DART SERVICE INSTRUCTION

TO AMEND INSTALLATION INSTRUCTIONS II145-6 Rev. A,
REF. TCCA STC: SH21-24
REF. EASA STC: 10077436
REF. FAA STC: SR04694NY

The purpose of this DART Service Instruction is to provide the installer with instructions for correcting these deficiencies.

FIGURE 1: RIVET REPLACEMENT LOCATION

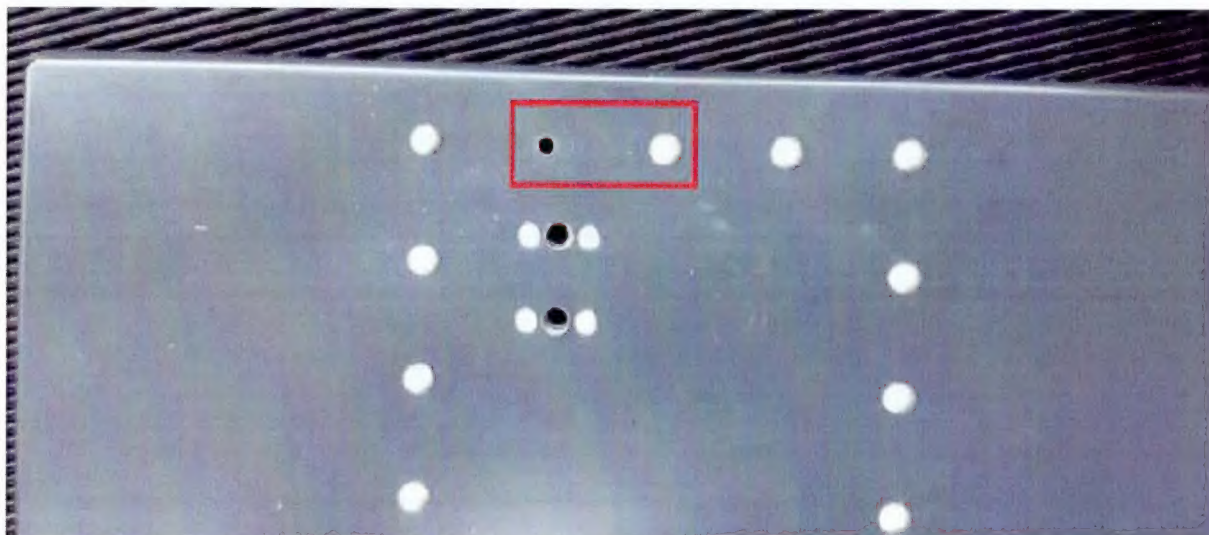
1. Dimple the aluminum panel in the required rivet locations as shown in Figure 1 of this DSI in accordance with the Aircraft Maintenance Manual.
2. Replace rivet F/N 89, MS20470AD3-3, with countersunk rivet, DIN65399-3205BF.

FIGURE 2: OEM LOWER BRACKET PIN

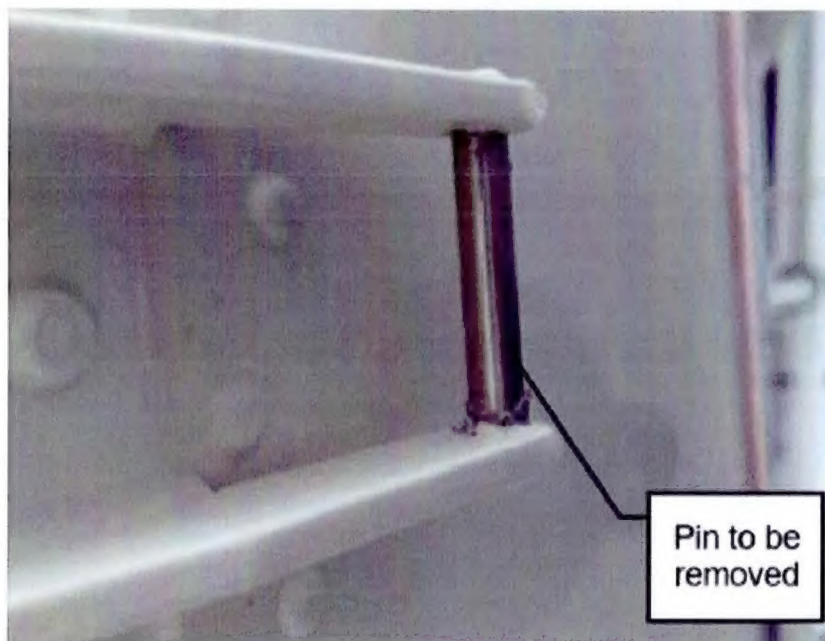
1. Remove the pressed pin, located on the OEM lower bracket, shown in Figure 2 of this DSI.
2. When installing the DART reservoir bracket, P/N 651.4010, on the OEM fixed provisions, use the alternate hardware listed in Table 4 on page 14 of II145-6 Rev. A.
3. The bushings (P/N 654.9810) internal diameter can be increased by up to 0.03" (.75 mm) to allow for proper fitment of the DART removable hardware onto the OEM fixed provisions.
4. Complete the installation of the DART brackets and reservoir per Section 2.3 of II145-6 Rev. A.

Pin to be
removed

FIGURE 3: FLOAT RESERVOIR ALIGNMENT (APPROX. DIM.), RH HC VIEW

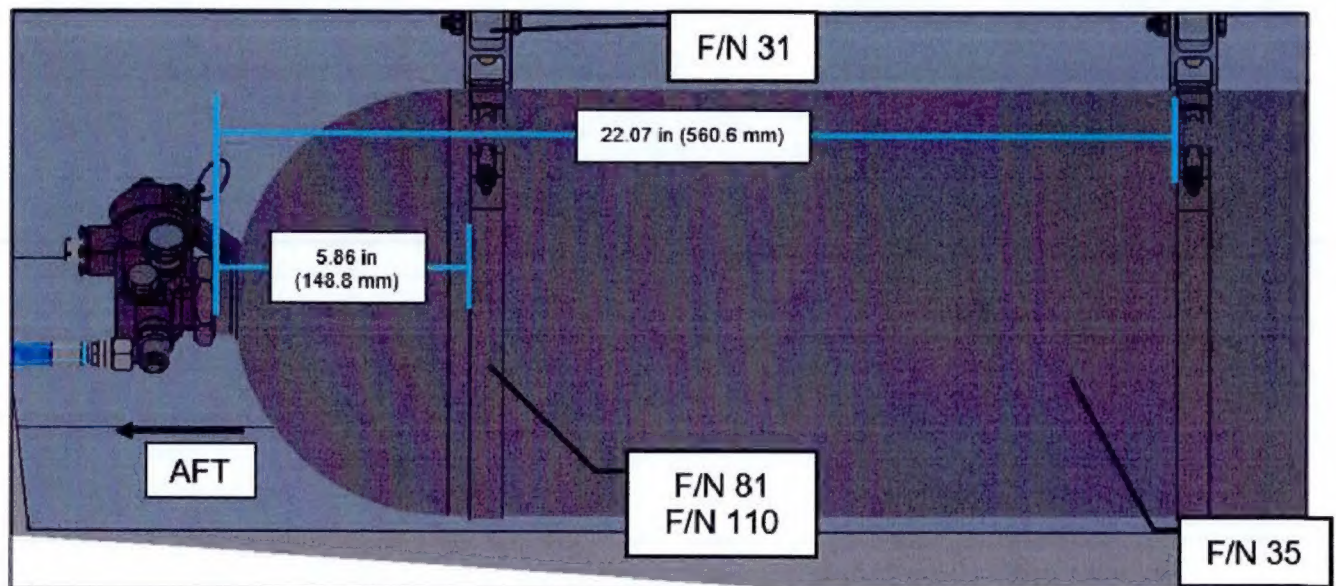
1. Reference Figure 3 of this DSI for the correct alignment of the Float Reservoir.
2. It is acceptable to shift the Float Reservoir aft by up to 2.90" (73.7 mm) to avoid interference with the DME antenna. If the bottle is shifted, the installer must confirm that the cable installation conforms to the NOTE on the bottom of page 50 of II145-6 Rev. A as well as the pull force requirements per Section 8.0 of II145-6 Rev. A.

NOTE: The float reservoir may be shifted by up to 2.90" (73.7 mm) aft of the dimensions shown in this figure to avoid interference with the DME antenna

FIGURE 4: LIFERAFT RESERVOIR CLAMP ALIGNMENT

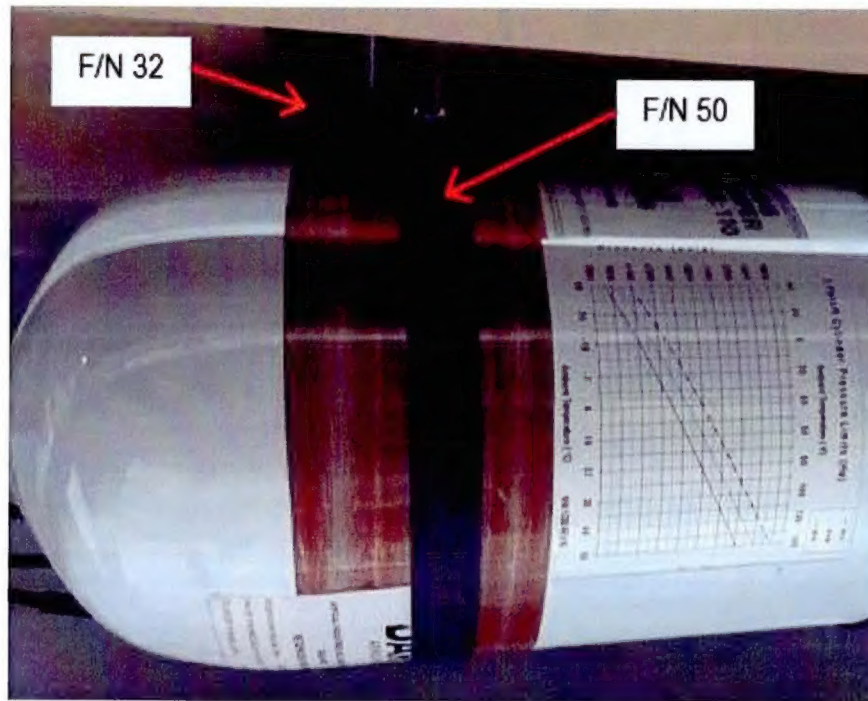
1. It is acceptable to install the clamp assemblies (F/N 50) such that the bolts are internal to the bracket assemblies (F/N 32) to prevent interference with passenger entry. Reference Figure 4 of this DSI for optional clamp orientation.
2. Reference Figure 5 for correct alignment of the Liferaft Reservoir. It is acceptable to shift the bottle aft by 1.0" (25.4 mm) while ensuring that the valve assembly clears the existing drain. If the bottle is shifted, the installer must confirm that the cable installation conforms to the NOTE on the bottom of page 57 of II145-6 Rev. A as well as the pull force requirements per Section 10.2 of II145-6 Rev. A.
3. It is acceptable to use either two washers or one washer (F/N 54) per bolt (F/N 56) to install the multi-cable box (F/N 60) to the cable box mount assembly (F/N 33) per Figure 15 of II145-6 Rev. A.

FIGURE 6: CLICK BOND LOCATION (APPROX. DIM.)

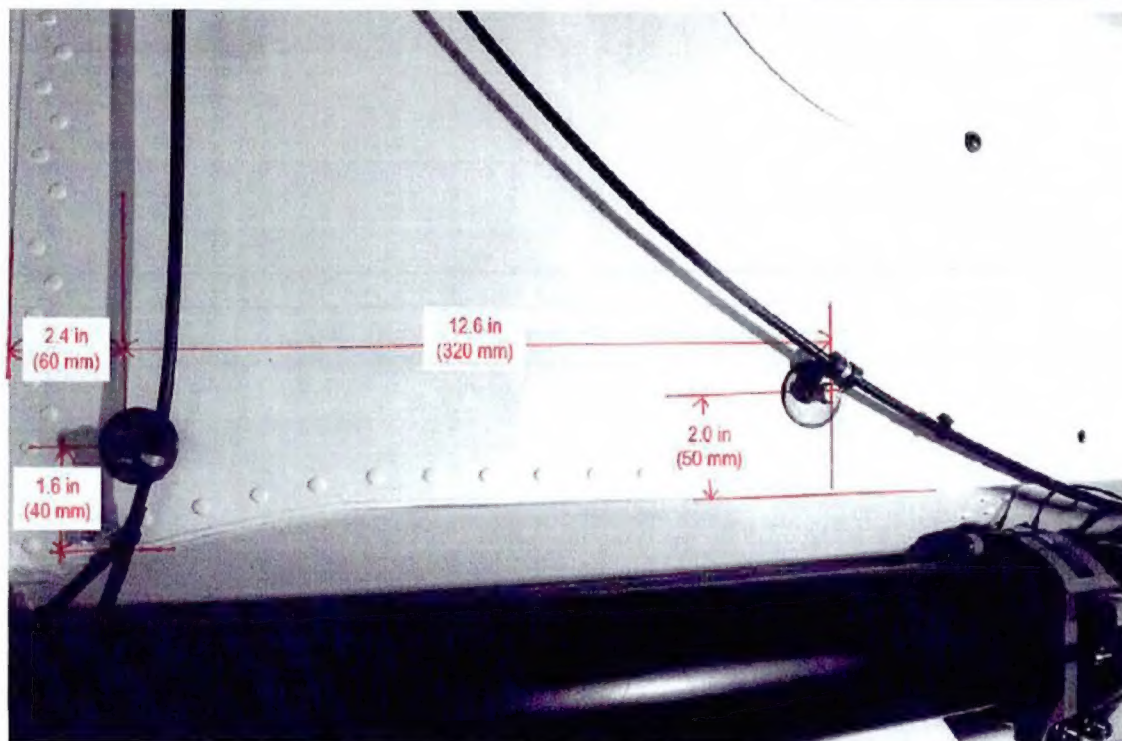
1. Rubber material may be used between the pull cables and Tywraps to allow for minimal cable movement and reduce chafing on the pull cables.
2. Reference Figure 6 - Figure 11 of this DSI for acceptable Click Bond (F/N 37) locations. A tolerance of 2.0" (50 mm) is acceptable on all dimensions. Additional Click Bonds may be required to remove any slack that may cause contact with the aircraft or other surrounding features.
3. The installer must confirm that the cable installation conforms to the NOTE on the bottom of page 50/57 of II145-6 Rev. A as well as the pull force requirements per Section 8.0 and Section 10.2 of II145-6 Rev. A.
